CITY OF ALBUQUERQUE

PLANNING DEPARTMENT – Development Review Services

RE: Warehouse Addition -2655 Baylor Drive SE
Grading & Drainage Plan
Engineer's Stamp Date 6-30-2014 (File: M16D006)

RESPONSE TO COMMENTS DATED JUNE 4, 2014 FOR WAREHOUSE ADDITION AT (2655 BAYLOR DRIVE S.E.) M16-D006

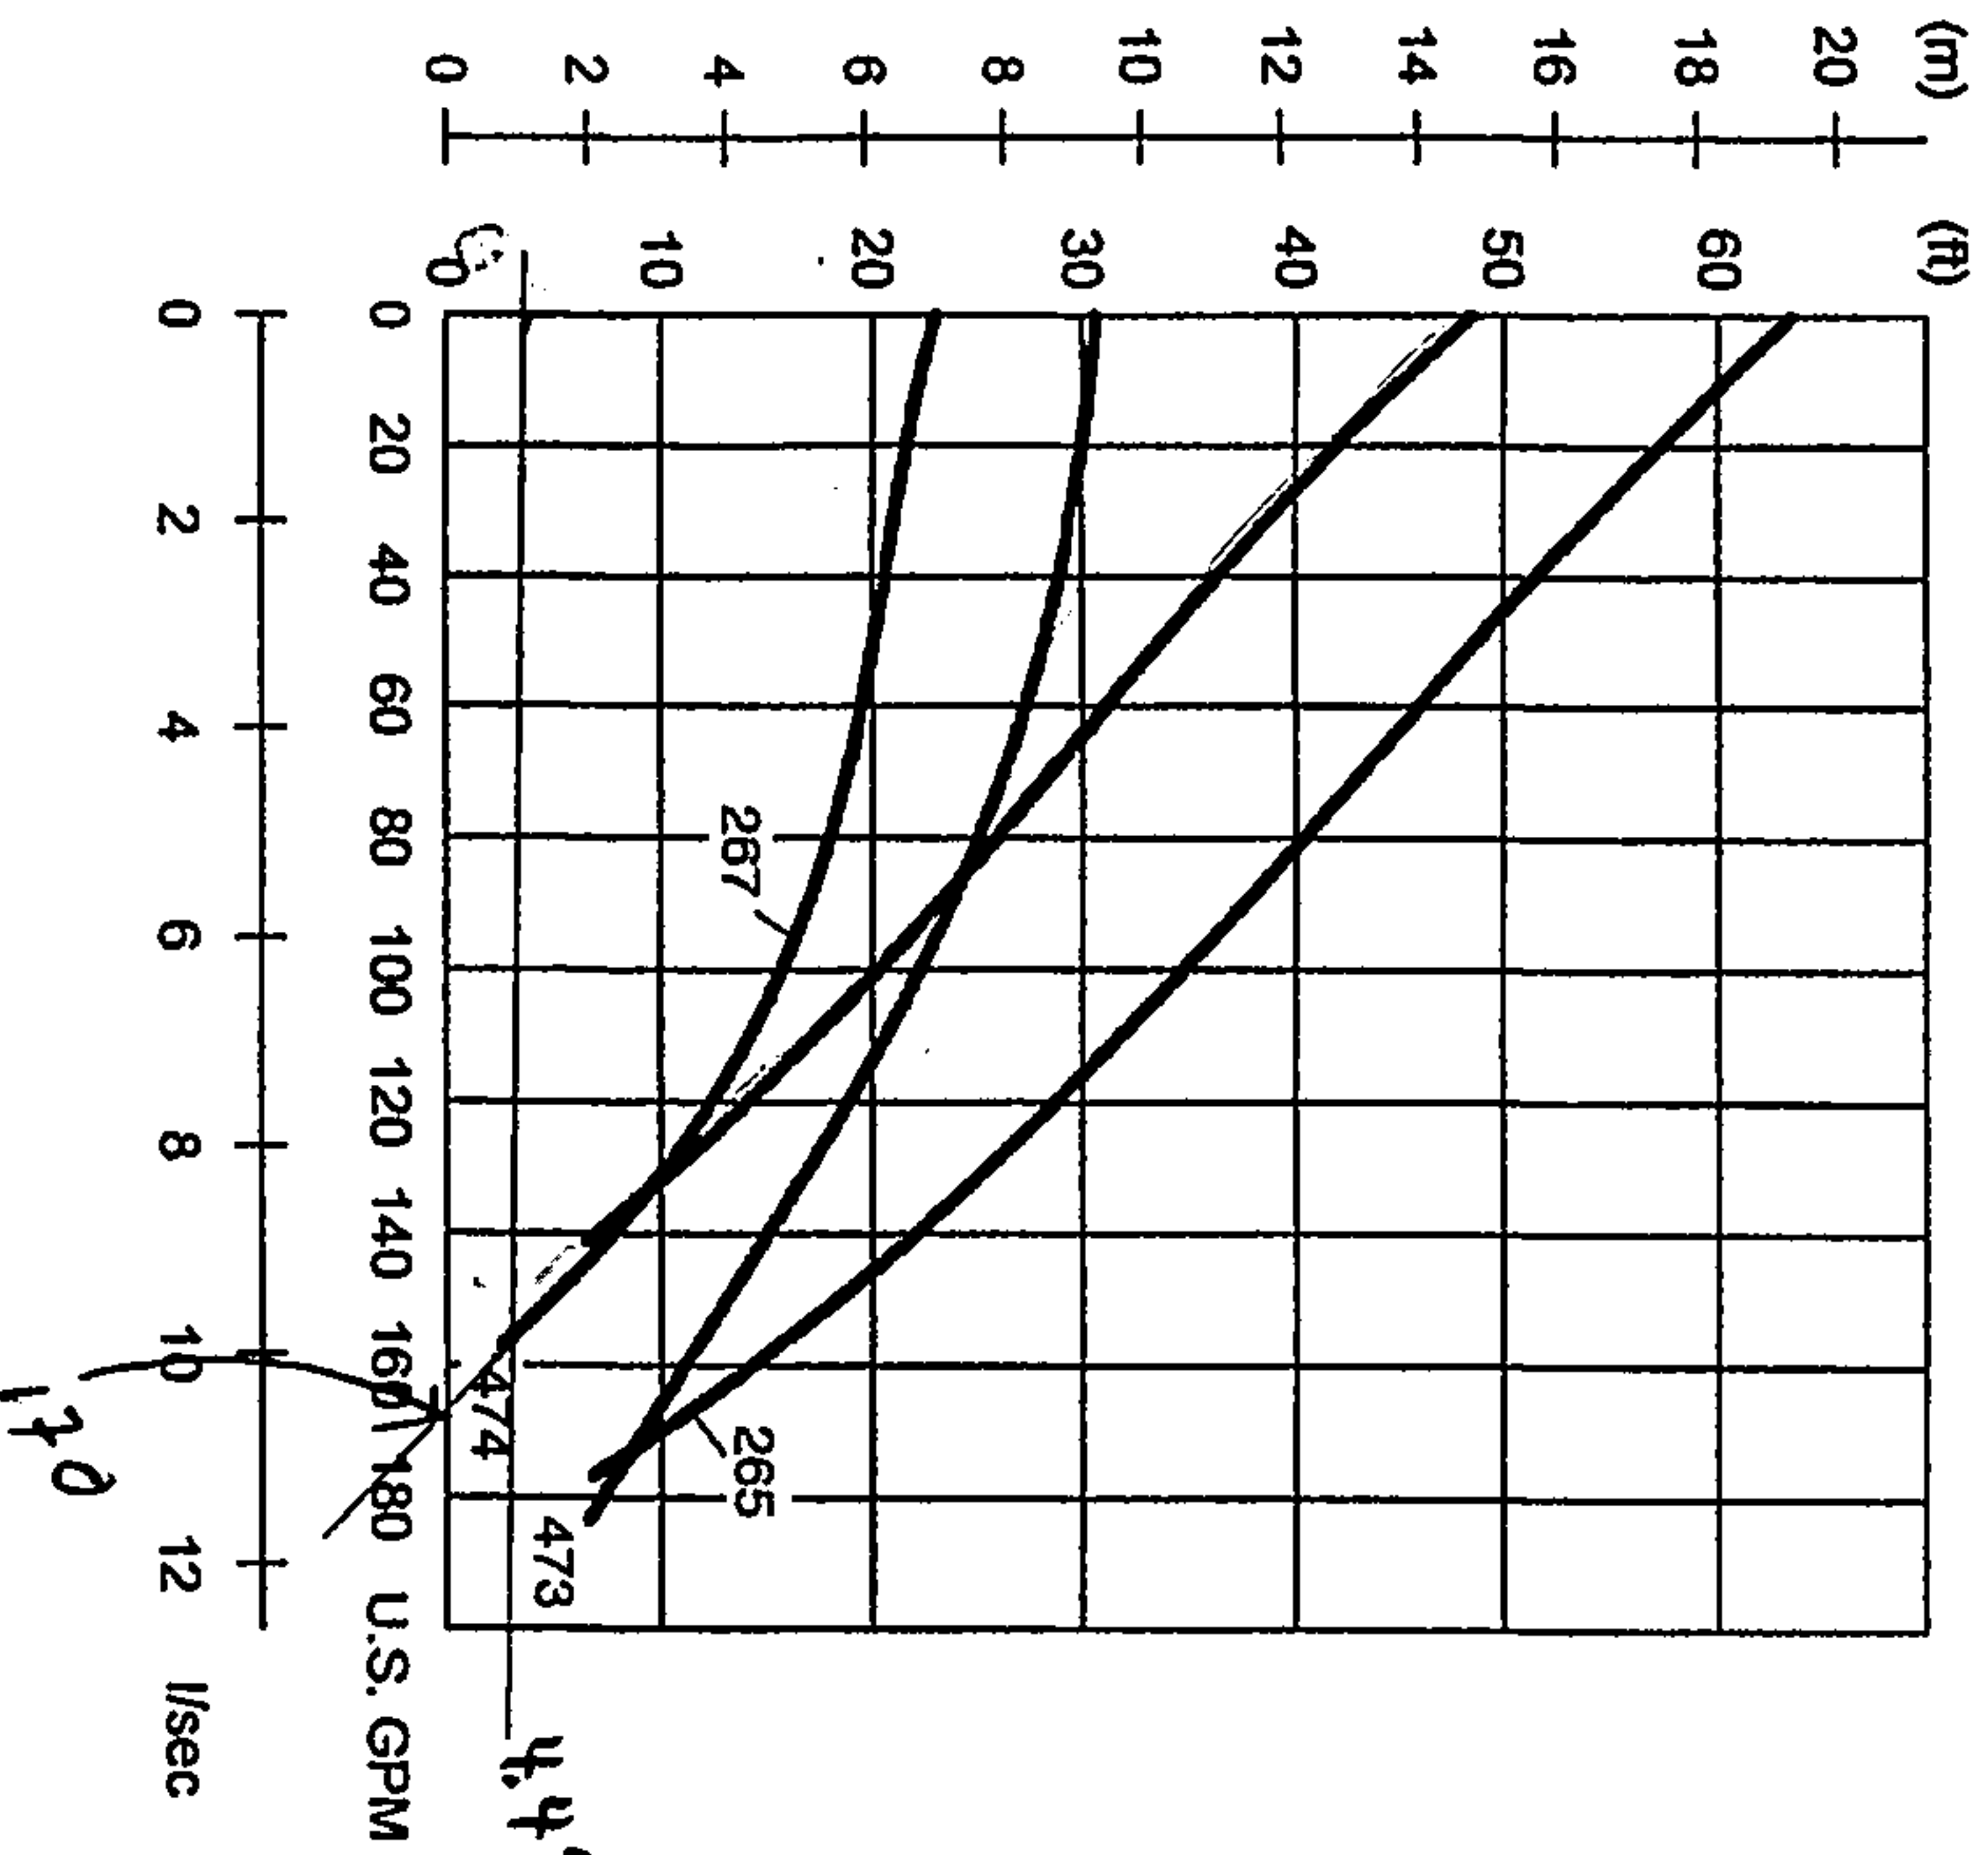
- 10) Clearly indicate on the pump cut sheets what pump is selected and which line to follow on the line graph.

9. The SO 19 notes need to be on the first sheet and clearly visible. *Notes and sign-off block has been inserted on the first sheet of the plan drawing.*
10. Clearly indicate on the pump cut sheets what pump is selected and which line to follow on the line graph. *Pump cut sheets have been marked to identify pump to be used along with depth and rate.*
